Council assessment of Clause 4.6 request

The applicant has lodged a Clause 4.6 variation submission to vary the height control in Clause 4.3 of Blacktown Local Environmental Plan (BLEP) 2015. A copy of the applicant's Clause 4.6 submission is at attachment 8.

Figure 1: Extract from the Height Plane Diagram demonstrating the overlay of the 16 m height plane and the parts of the development which are above the permissible height plane (shown in white)

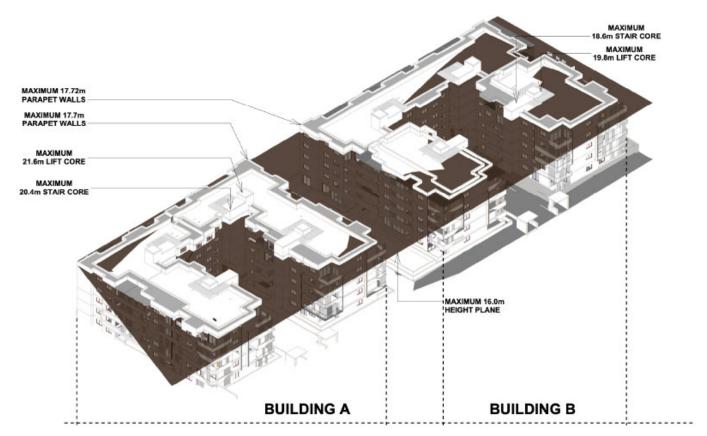
The areas of height exceedance relate to the portion of the uppermost level of the buildings and then elements of the parapets, fire stairs and the lift overrun that will provide access to the common open space at the rooftop level.

- 17.7 m (10.62% departure) to the parapet walls
- 21.6 m to the lift overrun (35% departure) of the building that provides access to the rooftop
- 20.4 m to the stair core

- 17.72 m (10.75% departure) to the parapet walls
- 19.8 m to the lift overrun (23.75% departure) of the building that provides access to the rooftop
- 18.6 m to the stair core

The following figure identifies the portions of the development that exceed the 16 m height limit under Clause 4.3 Height of Buildings under Blacktown Local Environmental Plan 2015, and portions of the development below the height limit. Areas that exceed the height limit are shown in white.

Habitable Areas Above 16m Height Plane Variation Range: 0-199mm over Building A - Level 4 - Site Coverage: 1601.6sq.m Building A - Area above 16m Height Limit in Variation Range: 1160.2sq.m (72.4%)

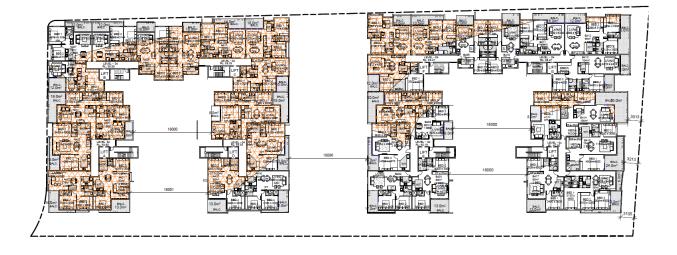
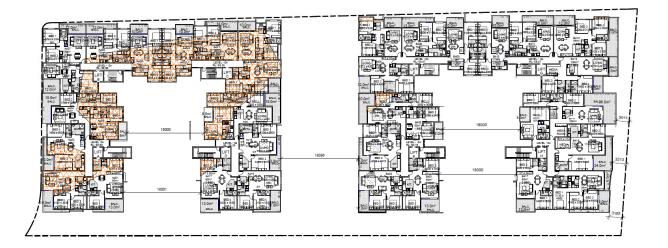
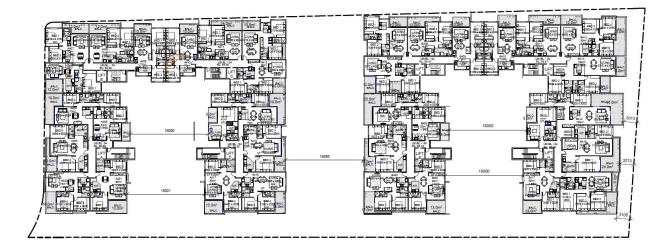
The habitable space above the height limit in Building A will range from 0.199 m (covering 72.4% of Level 4) to 2.26 m (covering only 0.5% of Level 4). The maximum height exceedance of 2.26 m relates only to the roofline of Unit A410's bathroom at the most top floor level of the building.

The habitable space above the height limit in Building B will range from 0.199 m (covering 25.1% of Level 4) to 0.78 m (covering only 1.1% of Level 4). The maximum height exceedance of 0.78 m relates only to the roofline of Unit B404's bathroom at the most top floor level of the building.
